TOWN OF PLAINFIELD DESIGN REVIEW COMMITTEE REPORT

CASE NO.: DP-21-061

REQUESTED ACTIONS: Architectural and site design review for a proposed office building

LOCATION: 1916 Crown Plaza Blvd.

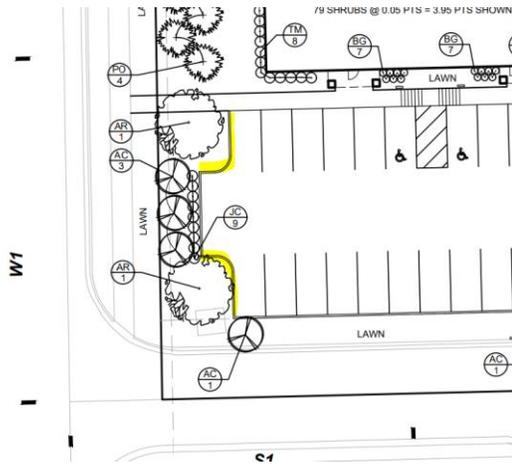
The primary building material on each elevation is brick.
